G.O. No. B.P. No.	2540 – W	Press. Mis.
Dated	28-9-1882	198

The estimate amounting to Rs. 6,644, for erecting a monument over the grave of the late Right Honorable W. P. Adam, at Ootacamund, is sanctioned.

The Late Right Hon'ble W. P. Adam.

Estimate amounting to Rs. 6,644, for erecting a monument over the grave of — at Ootacamund, sanctioned

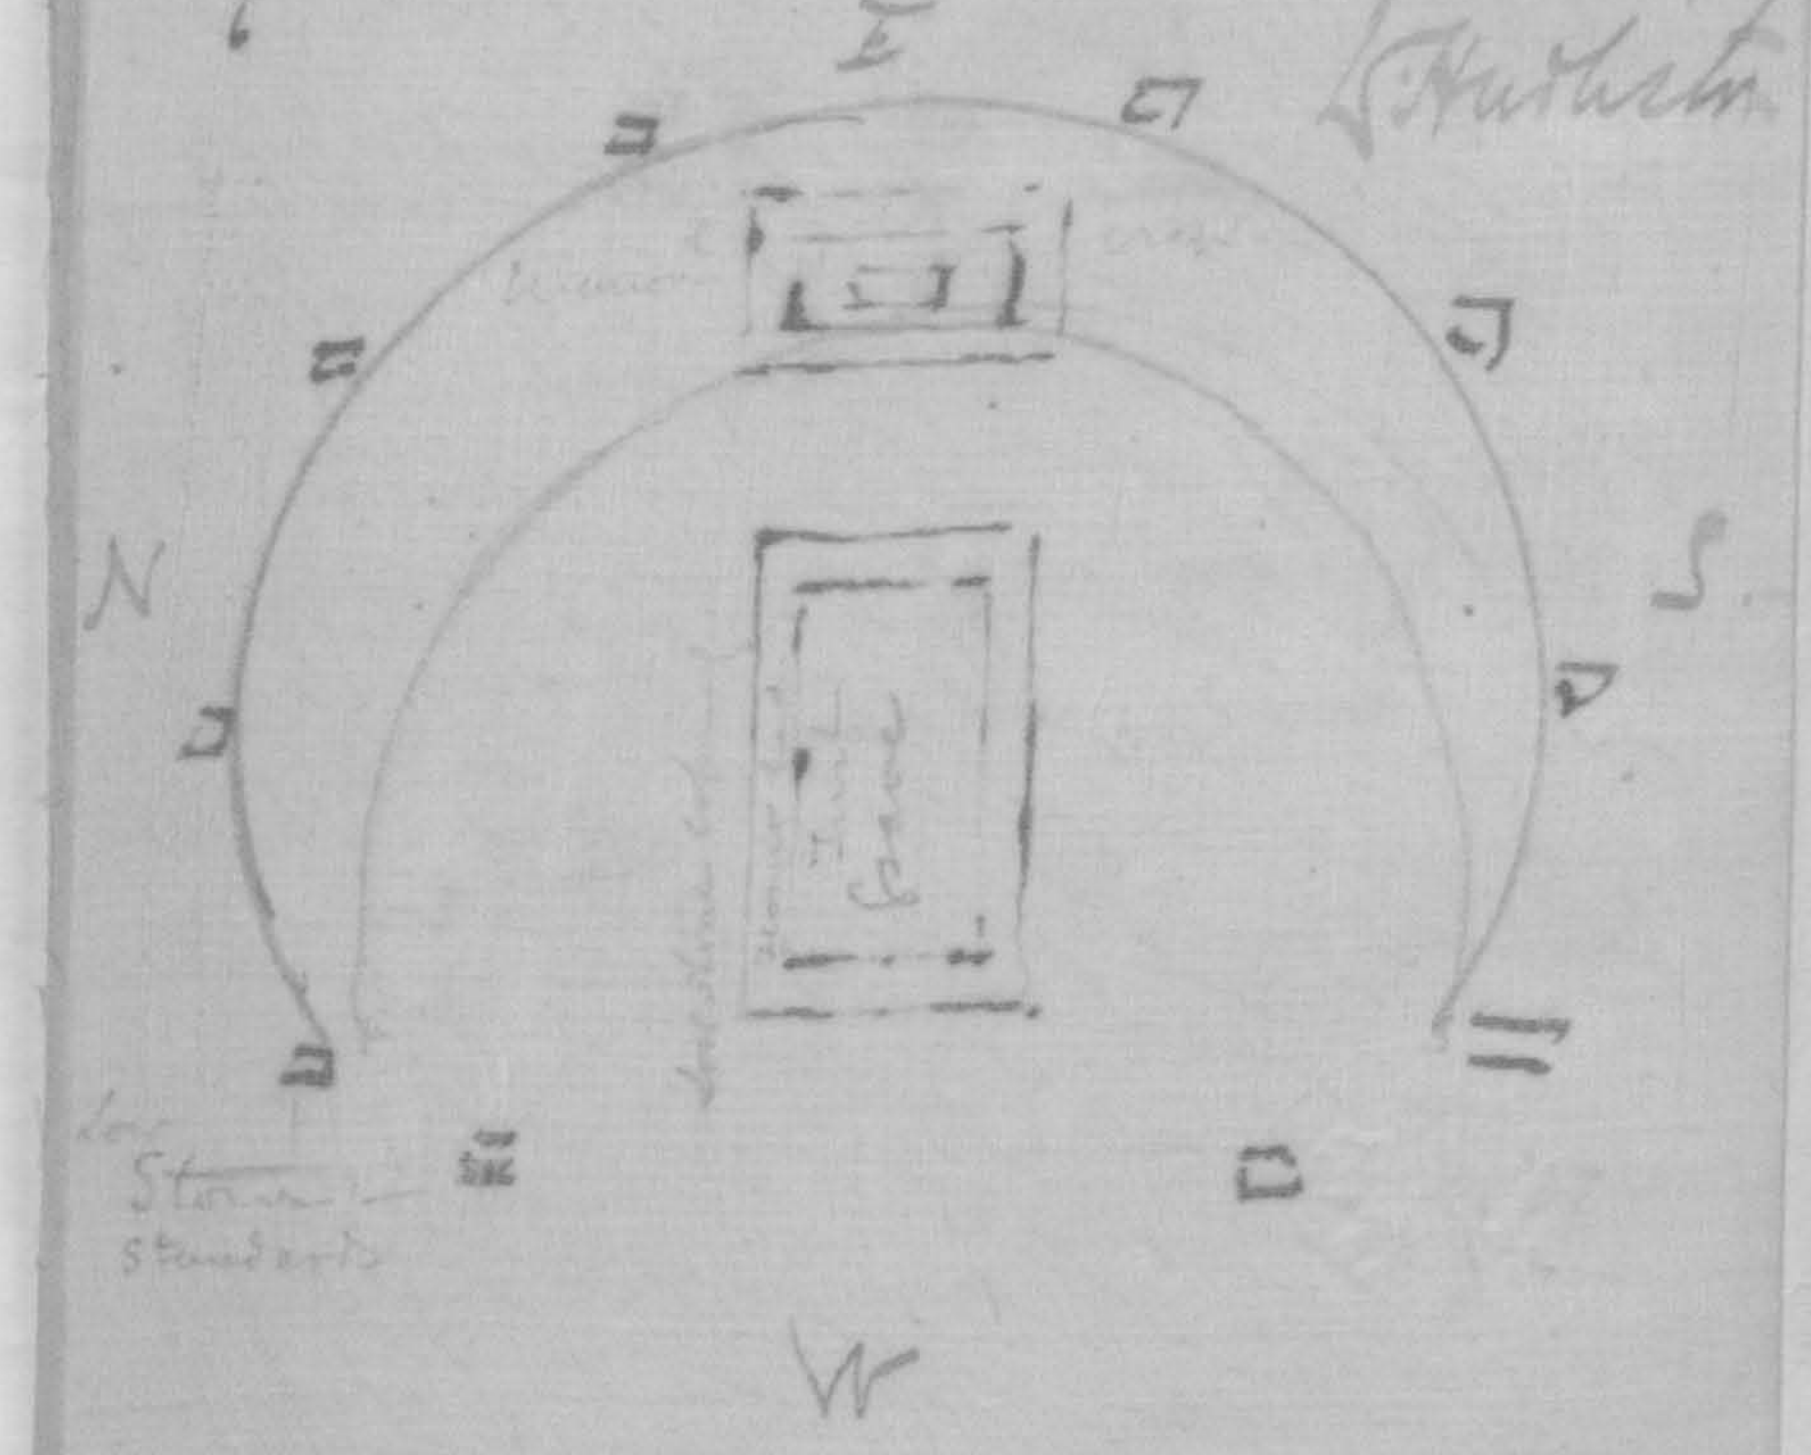
I told you that Mrs. Adam
questioned whether the design
was not too clumsy

for stability. but that I thought this was a mistaken idea derived from the drawing being not in perspective but merely an architectural elevation. You will doubtless settle the point with the Chichesters

The Inscription altered as approved is in the packet. It is to be in raised letters

it should be I think on the base. not on the pedestal of the Column - the only

other suggestion I w^d. ask you to consider with the Chis Column (as I shall write him) is whether the actual limits of the masonry grave sh^d. also be outlined by a low open work stone coping - ab^t. 8 or 10 inches

above ground. Casing for
Brooke's grave in St Stephens
Chyd. I want to enclose
the little flower bed - &
the mound within it. I
think something of the
kind is certainly needed
to mark the actual grave
as the Memorial column
cross is as I understand

to be on the raised turf
slip - at the foot of the
grave & somewhat
above it. Then the
wooden cross now stands
& not on the grave
itself.

The low stone
standards at intervals
with or without chains

linking them – shd. I think outline the whole horseshoe formed at the site. & shd. not be narrowed to the mere grave: in fact my idea is this. – yrs sincly
